REMEDIATION SYSTEM EVALUATION

57th and North Broadway Site
Wichita, Kansas

Report of the Remediation System Evaluation,
Site Visit Conducted at the 57th and North Broadway Site
January 12, 2006

FINAL REPORT
JUNE 16, 2006

Figure 1 Site Map

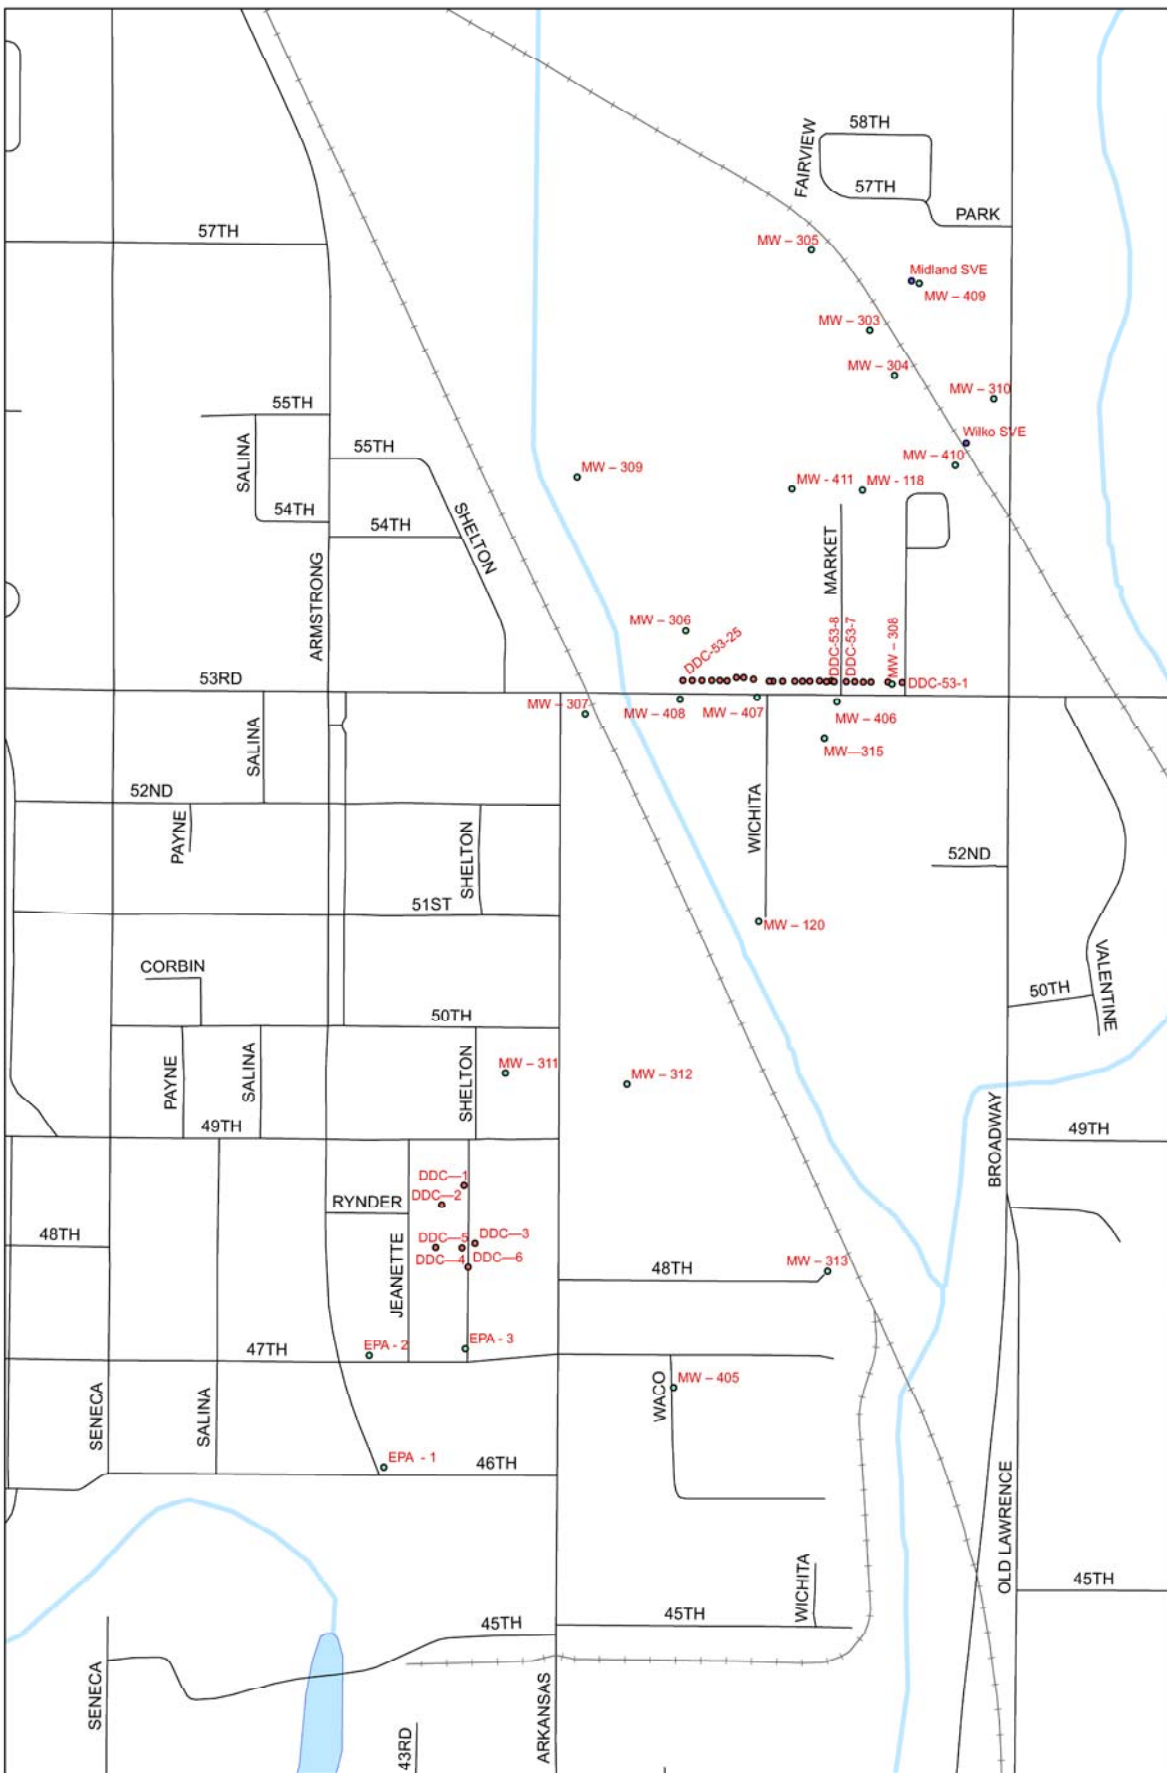
At the time of the RSE site visit there were no formal maps available that comprehensively show all site features. Most maps provided to the RSE site team do not include significant site features such as:
